Product Change Notice (PCN)

PCN Number: PCN-0450073R-01

Product(s) Affected: *MJ-3536*

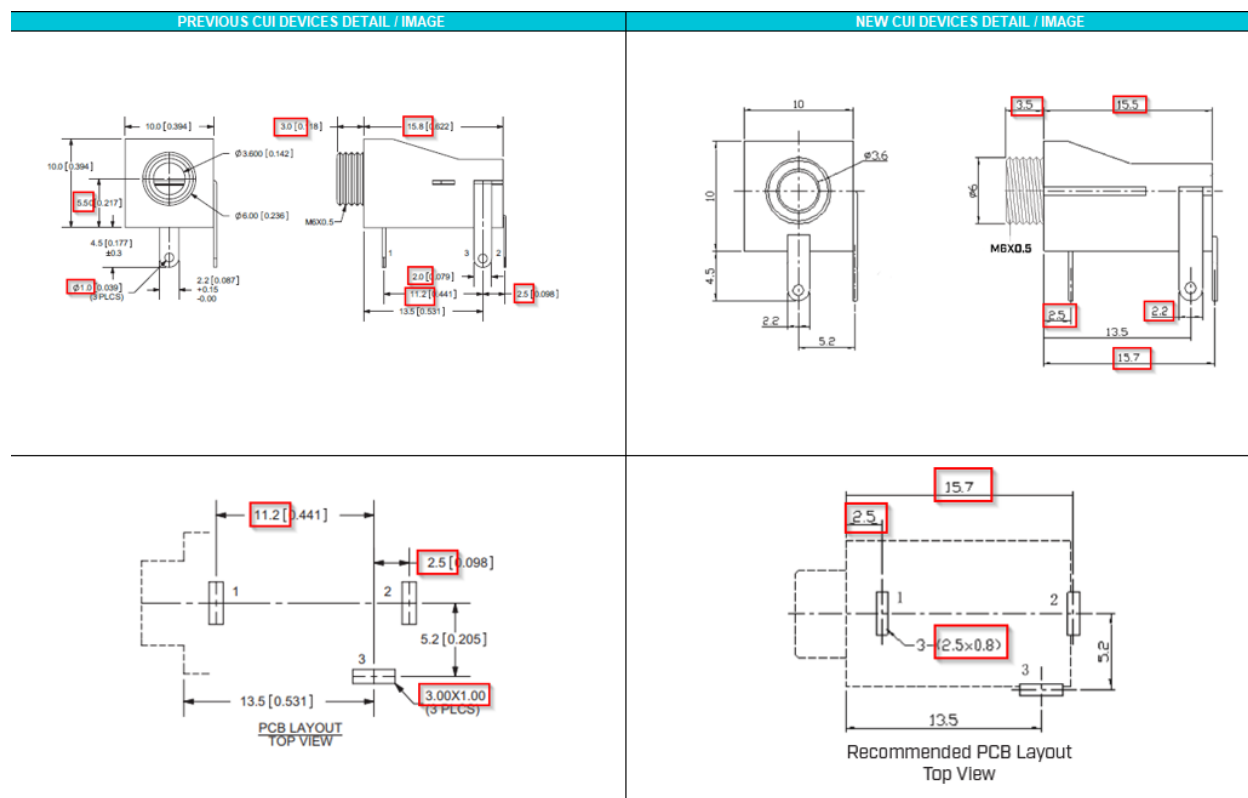
Description of Change: *Minor Housing and footprint differences. Material Change on the housing and terminals. See image Below*

PREVIOUS CUI DEVICES DETAIL / IMAGE			NEW CUI DEVICES DETAIL / IMAGE		
	MATERIAL	PLATING	DESCRIPTION	MATERIAL	PLATING/COLOR
terminal 1	brass	tin	terminal 1	brass	silver
terminal 2	copper alloy	tin	terminal 2	brass	silver
terminal 3	brass	tin	terminal 3	brass	silver
bushing	brass	nickel	bushing	brass	tin
plastic	PBT		housing	PA (UL94V-0)	black
